Saughton Park to QuietRoute 8 Walk and Cycle Improvements Consultation Report

April 2018

This report summarises the consultation exercise undertaken during the preliminary design stage of walking and cycling improvements between Saughton Park and QuietRoute 8.

Figure 1 Saughton Park to QuietRoute 8 Proposals (1 of 7)

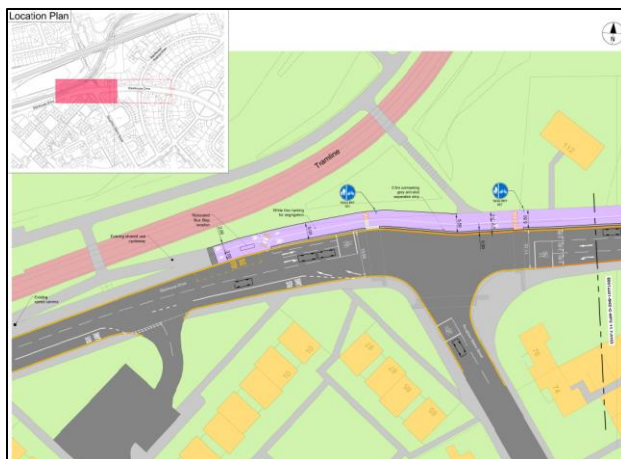
Issue	No. of Responses
Concerned about the switch of sides for cyclists on the Stenhouse Drive footway	2
Concerned regarding footway width on Stenhouse Drive	2
Would like to see guardrail removed	2
Concerned regarding conflict at bus stop on Stenhouse Drive	2
Would like to see unnecessary signage and street furniture removed	2
Would like waiting and loading restrictions on Stenhouse Avenue West to provide protection to the cycle transition point	2
Would like waiting and loading restrictions around the cycle bypasses on Whitson Road	2
Would like the effective widths between the bollards and the kerbs at the cycle bypasses to be widened	2

Issue	No. of Responses
Dropped kerbs need to be provided where Whitson Place East and Whitson Place West meet Whitson Crescent	2
Would prefer the Toucan crossing across Stevenson Drive at Balgreen Road to be a 'straight-across' crossing rather than staggered	2
There is a need to provide an accessible dropped kerb on Baird Drive at an area close to the start/end of the cycle path, including adequate protection from vehicles waiting / loading	2

Issue
Trees must have roots contained so that they don't break through the footway
Speeding vehicles and antisocial motorbike use are a problem in the area
Desire to see the streets become more pedestrian and child friendly
Desire to see the paths between Whitson Crescent and Stevenson Drive being widened

- Reduce the number of traffic lights (3)
- Widen the footway on the east side of Balgreen Road (3)
- Segregated cycleway(s) is / are required (2)
- Concerns about conflict on the footway / cycleway on Stenhouse Drive (2)
- Narrow road width / remove traffic lanes on Balgreen Road (2)
- Continuous footways [design comments / safety concerns] (2)
- Parking restrictions across accesses for cyclists are required (2)
- Upgrade the tunnel under the tram and rail lines (2)
- Improvements required on Pansy Walk (2)

Stenhouse Drive

- The council has a general approach to try and remove guardrail where possible. We will consider its removal at Stenhouse Drive.
- We will consider whether it is possible, within the scope and budget of the scheme, to provide cycling connections from Saughton Mains Street to the cycleway on Stenhouse Drive.

- We will consider whether red chipped surfacing along the segregated section of the cycleway is appropriate with reference to the Edinburgh Street Design Guidance.

- We shall provide an eastbound cycle access to the bus lane via a dropped kerb, with give way markings. Westbound we think it is appropriate for cyclists to join the cycleway via the raised table crossing of Stenhouse Avenue West.

- At the junctions of Stenhouse Avenue West/Drive, we shall extend the double yellow lines to protect the entry/exit point for cyclists. We shall also mark this entry point with cycle logos, arrows and give way markings to guide cyclists on and off the pavement.

- We will consider tightening the corner radii and including a raised table at first side road of Stenhouse Avenue West.
- We will consider adding a raised table across Stenhouse Avenue West at the junction with Stenhouse Gardens North. We will also consider tightening corner radii and adding raised tables across Stenhouse Avenue.
- We will consider double yellow lining in place of the current single yellow in order to prevent parking which would hinder sightlines at the entrance to the shared use footway.

- We shall include double yellow lining across the cycle accesses on Whitson Road and widen the gaps between the bollards to 1.5m.
- We will assess whether re-lining of the road markings along Whiston Road can be included in the scheme.
- Along Whitson Road and Stenhouse Avenue, we will consider ways to make the streets more pedestrian friendly and reduce the dominance of motor vehicles within the budgets available.
- Planters will be considered at the cycle bypasses, though we will need to ensure there are resources to maintain them.
- We will consider if more raised tables and corner radii tightening should be added to the junction of Stenhouse Avenue/Garden/Whitson Road.

- We will consider whether the paths connecting Whitson Crescent to the new crossing can be widened, however the close proximity of trees may be a limiting factor.

- On Stevenson Drive we will reassess whether bollards, which exist currently, can be removed and not replaced, similarly we will see whether the phone box needs to be re-positioned.
- We will include double yellow lines and dropped kerbs at the access points where the paths meet Whitson Crescent.

- We shall consider additional bike parking near to the bus stop on Stenhouse Drive.
- We will investigate removing or altering the fencing at the parade of shops beside Balgreen Road.
- We will re-assess the corner radii for buses turning left from Balgreen Road to Stevenson Drive.
- We will re-assess the pavement width at the corner of Stevenson Drive & Balgreen Road to see if the widening can be delivered.

- We will investigate implementing a hard-standing surface at the community garden area is desired by the local area team and those who look after the garden.
- We will assess whether further changes to the layout of Pansy Walk are required to improve conditions for walking and cycling.
- We shall investigate the verge parking on Pansy Walk to determine why it occurs and how it can be addressed to improve conditions for walking and cycling.

- Dropped kerbs, protected by double yellow lines, shall be included at the required access to the QuietRoute on Baird Drive.
